REMARKS

IN THE DRAWINGS:

*FIG. 7*

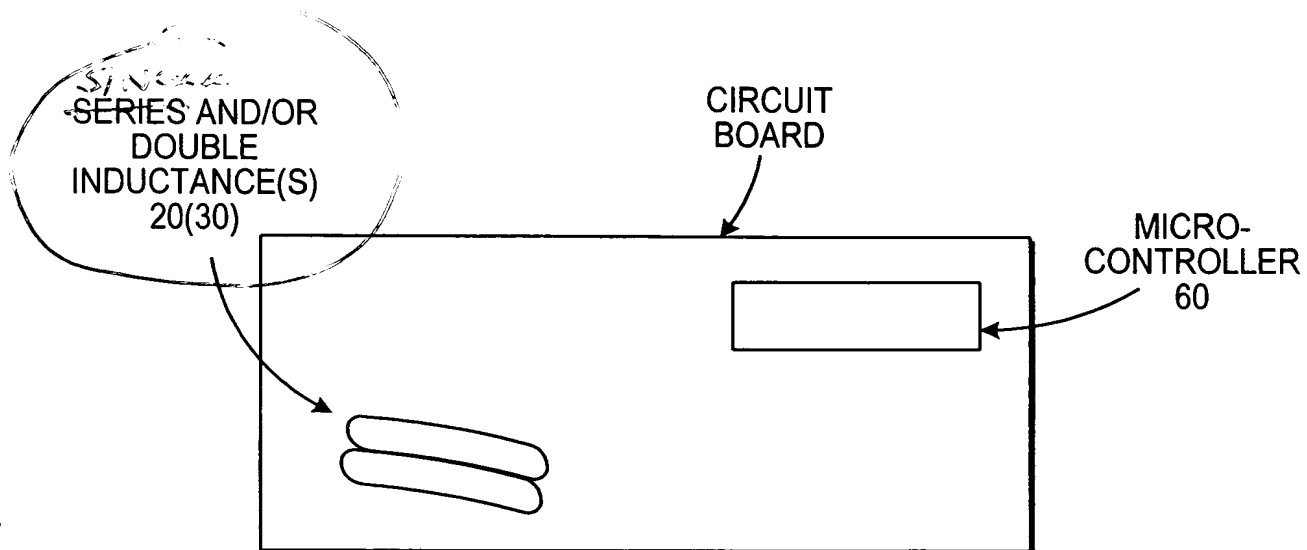
Fig. 7: Change “ SERIES AND/OR DOUBLE INDUCTANCE(S)” to
--SINGLE AND/OR DOUBLE INDUCTANCE(S) --;
